DESIGN CHANGES BASED ON PUBLIC INPUT

PUBLIC SCOPING MEETING | CSJ: 2121-02-166

November 30, 2022

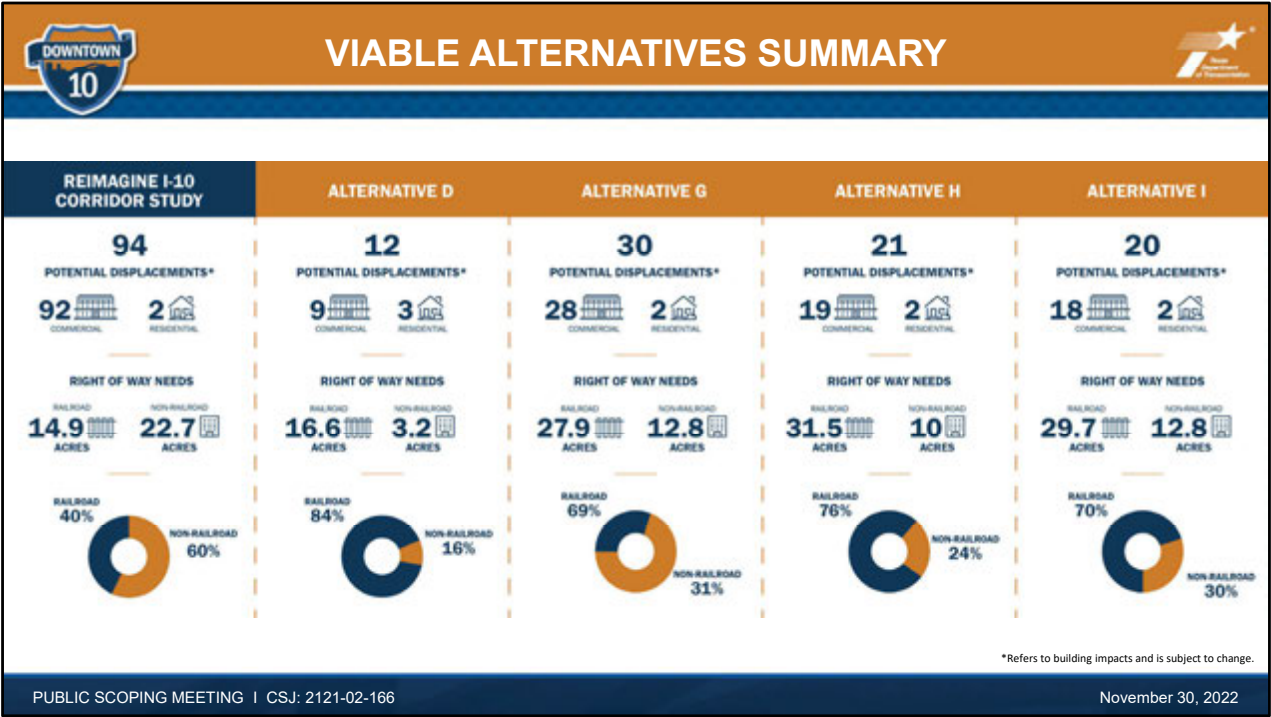
The comments TxDOT is addressing on this slide include the desire to not remove bridges in the downtown area, reducing speeds along Yandell Drive and Wyoming Avenue, as well as removing proposed U-turns in the downtown area in the viable alternatives.

Alternative I shown here and on the next two slides is an additional viable alternative that incorporates design changes mentioned in the previous two slides. In the Downtown area, the channelized right-turn at Yandell Dr was removed to reduce turning speeds and improve bicycle and pedestrian safety. Raised intersections were added at Santa Fe St to also reduce travel speeds and improve bicycle and pedestrian safety. Raised intersections in other locations are also being considered. The U-turns on the outsides of Downtown were also removed to improve bicycle and pedestrian comfort. These three changes were made to help address concerns related to speeding in the downtown area.

East of downtown, a two-way cycle track and wide sidewalk were added along the frontage roads to create bicycle and pedestrian corridors. Dedicated access roads for businesses were provided on the outsides of these bicycle and pedestrian corridors, allowing for improved access management along the frontage roads. The new configuration removes driveways along the frontage roads to address concerns about high-speed vehicles turning across the paths of bicyclists and pedestrians. The new bicycle and pedestrian corridors have fewer conflict points and interruptions and allow for a larger buffer from the frontage roads, which is expected to result in improved bicycle and pedestrian comfort.

Immediately west of downtown, a new westbound entrance ramp was added, and the eastbound exit ramp was moved closer to downtown. These changes are expected to reduce traffic volumes on the proposed frontage roads. Enhanced bicycle and pedestrian accommodations were added to the realigned Los Angeles Dr to Franklin Ave connection to offer an additional route between Sunset Heights and Downtown El Paso for bicyclists and pedestrians. And lastly, space surrounding the old Franklin Ave underpass could be repurposed as pedestrian plazas.
